Bolton Planning & Zoning Commission
Regular Meeting
7:30 p.m., Wednesday, April 14, 2021
Virtual Meeting utilizing Zoom
Minutes and Motions

a. Discussion/Possible Decision: Special Permit Application for Nursery and Value Added Agricultural Business, 1225 Boston Turnpike, Happy Town LLC (#PL-20-13)

SITE PLAN

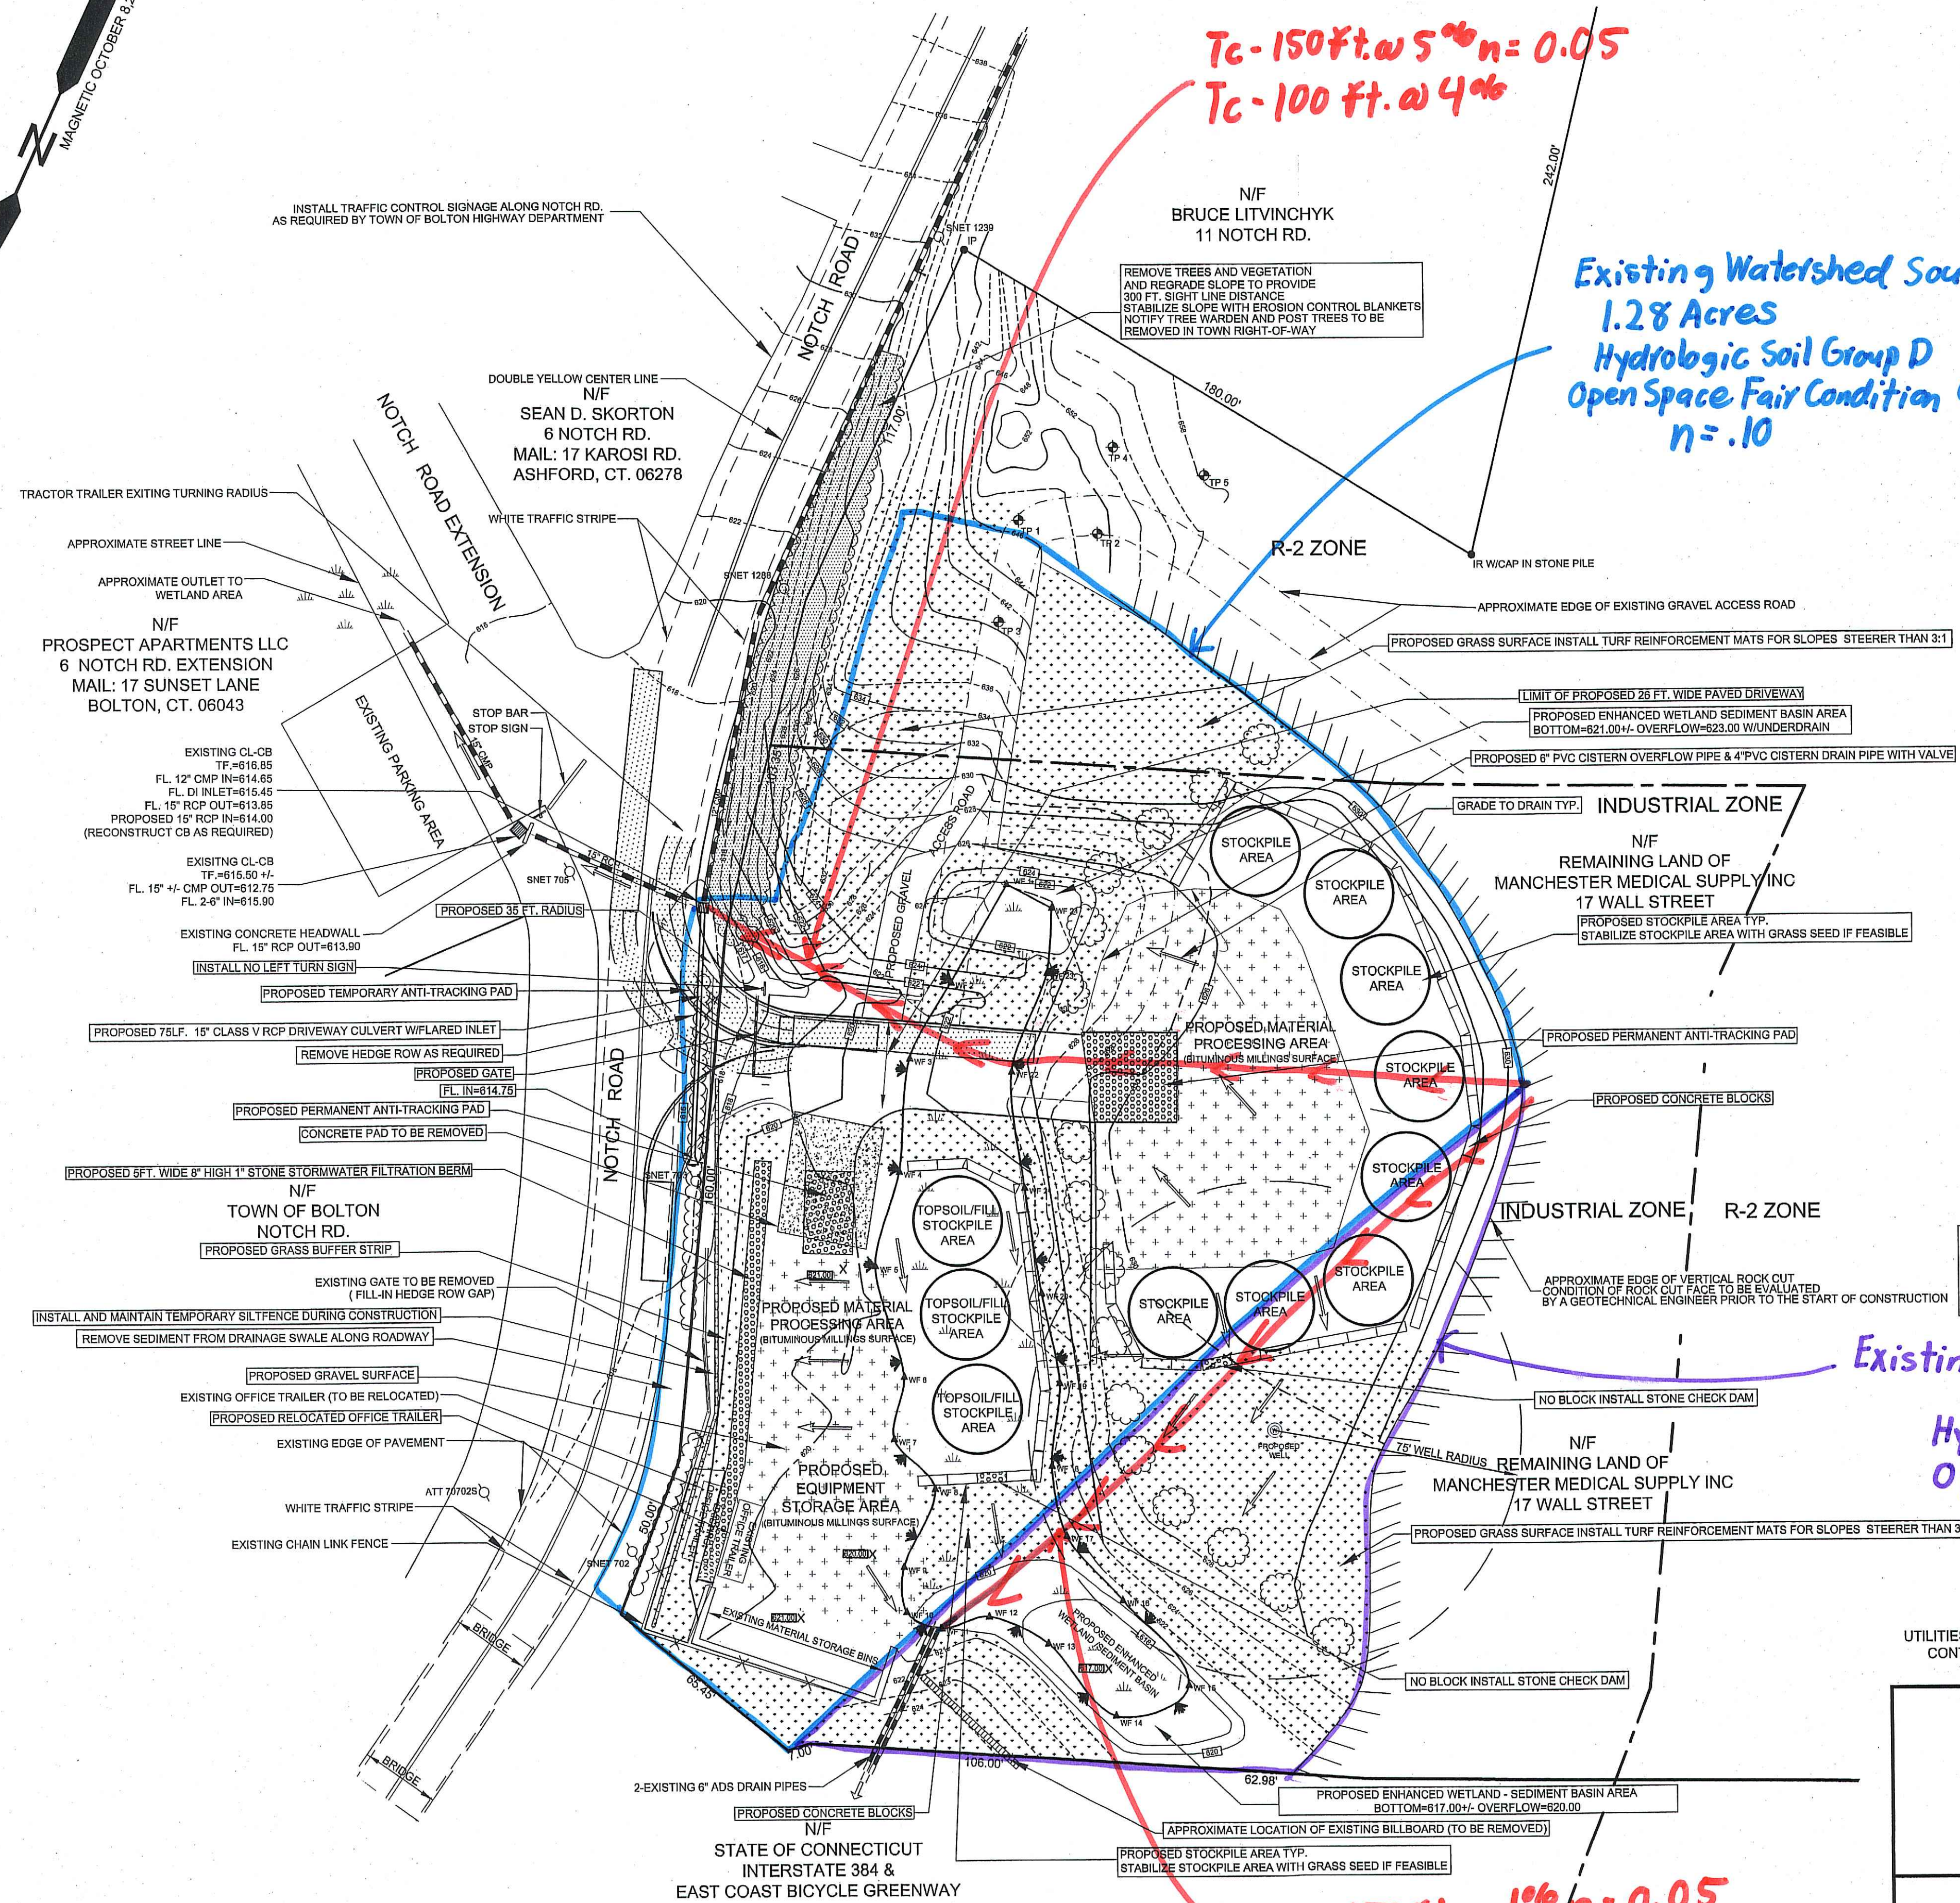
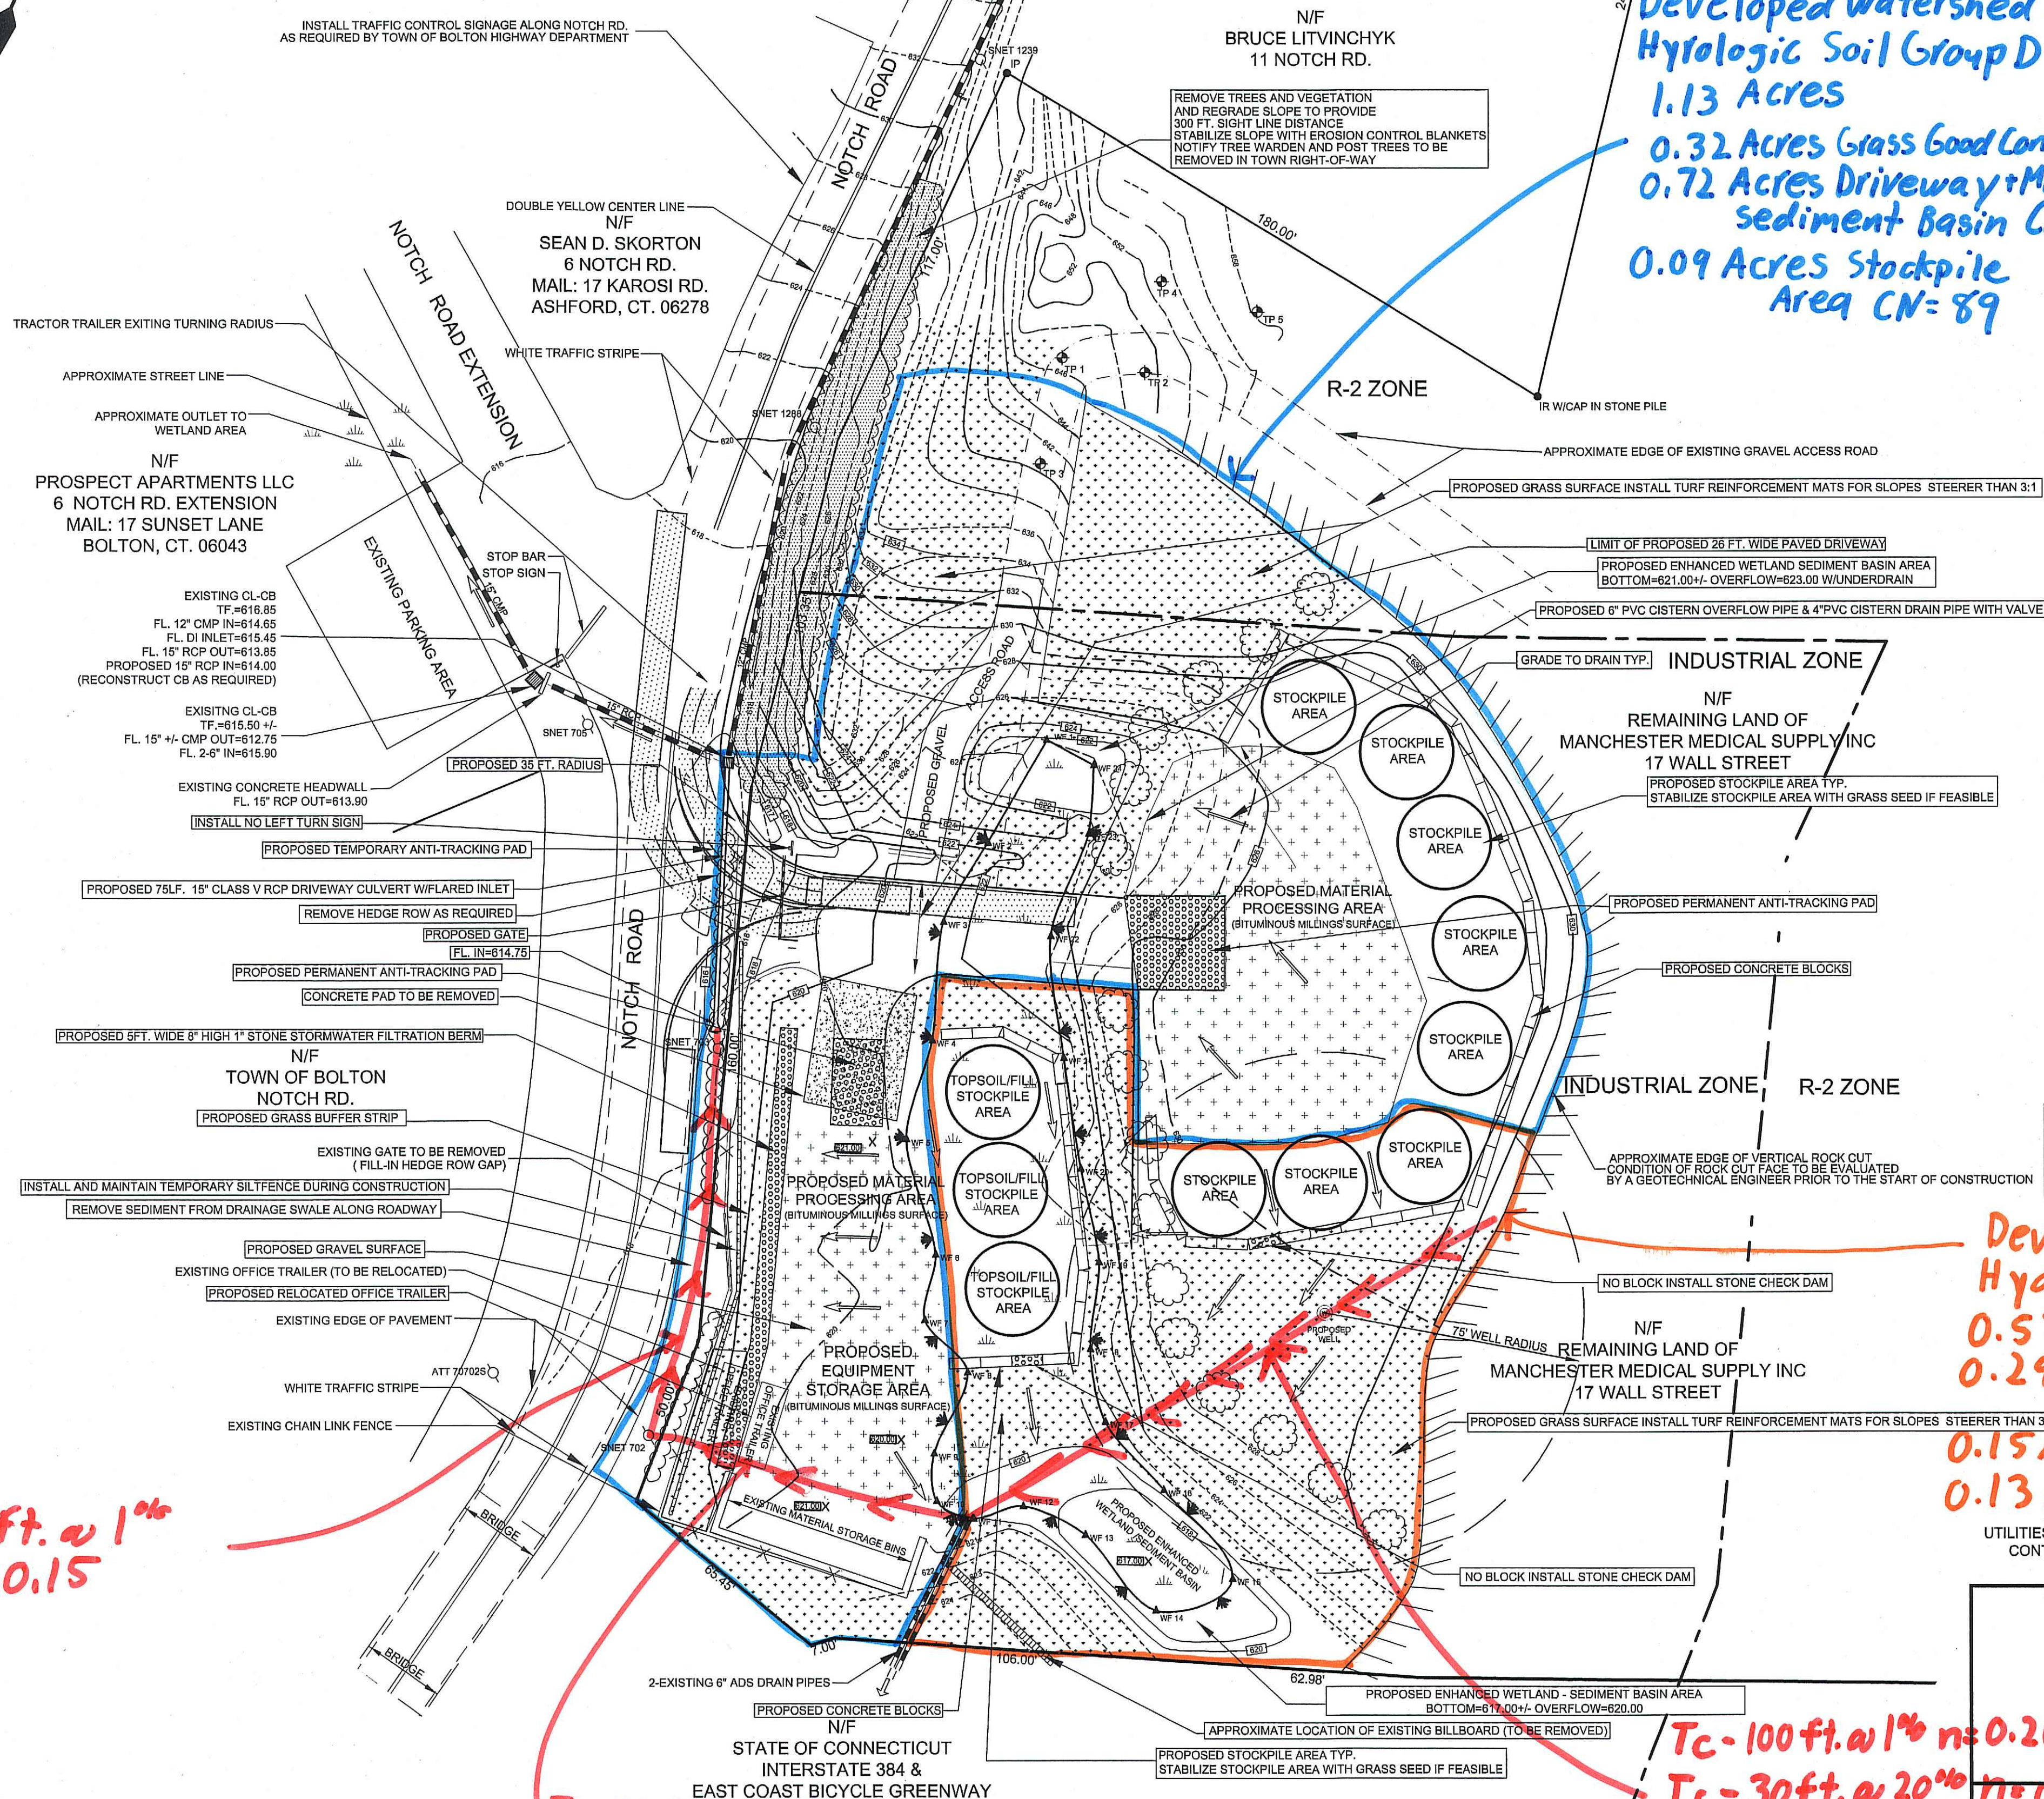
What exactly is going to be stored in the Stockpile areas shown on the site plan prepared for Landie Construction. What is going to be required of the applicant to ensure that there will be no runoff or leaching of any materials which could affect the ground water in our neighborhood? Are there any restrictions on what can be stored?

3. Nowhere on the site map do I see a water supply (well) nor any sanitary sewer plans for the workers who will be there. What will be done about that?

Figure ~ 1

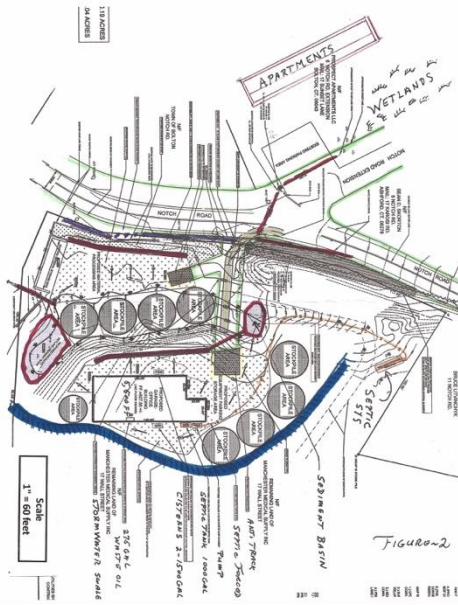
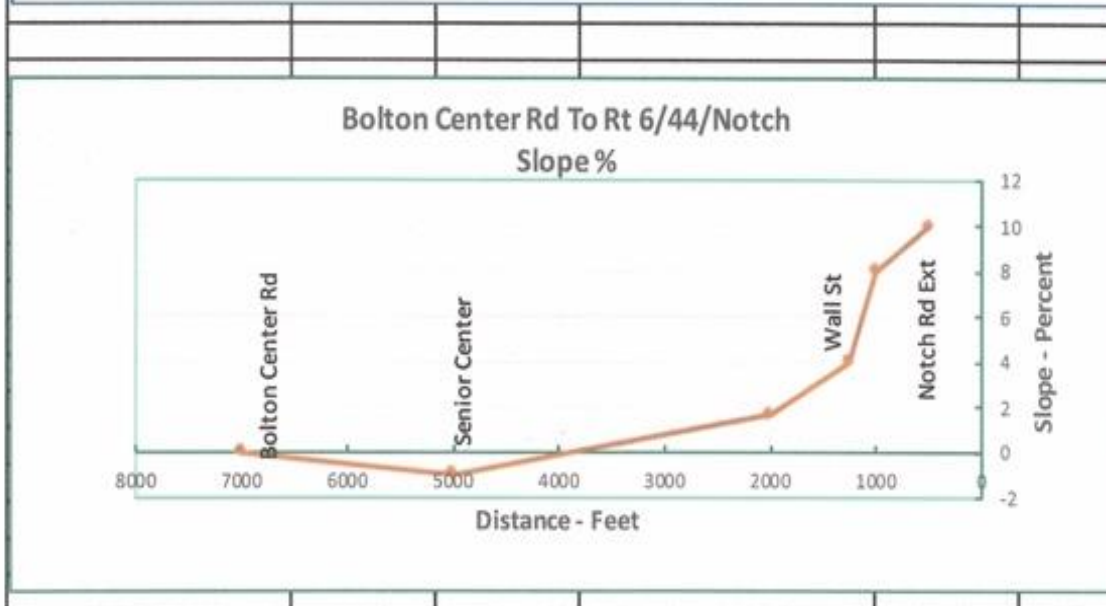
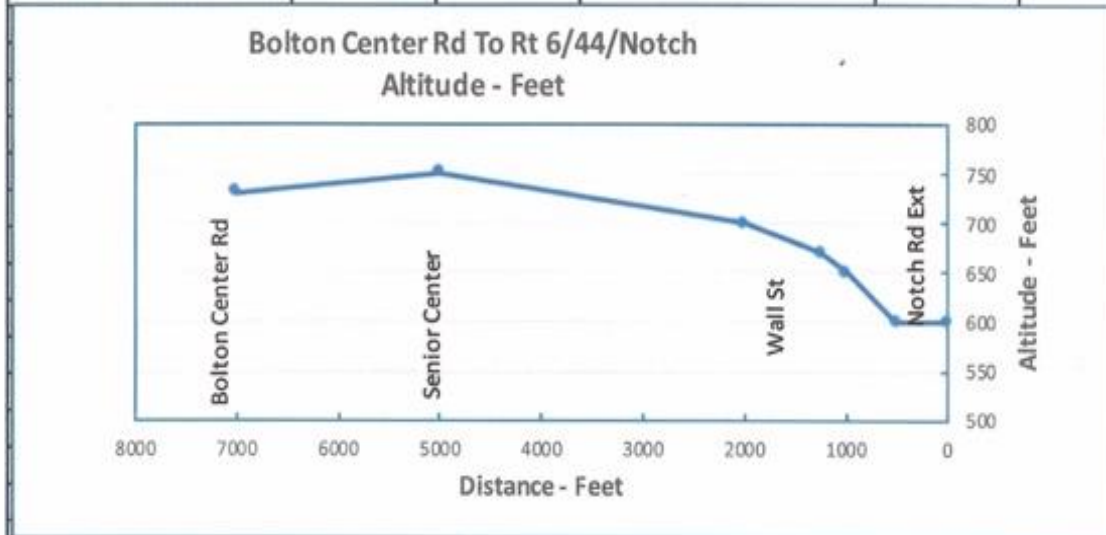
At the bottom of Notch Road (at approximately 6 Notch Road) there is a steep incline. Please see (Figure 1) for slope information that was taken from a US Geological Survey Map. This data shows a max slope of approximately 10 percent at the intersection of Notch Road and Notch Road ext. A steep incline is considered to be above 6 percent.
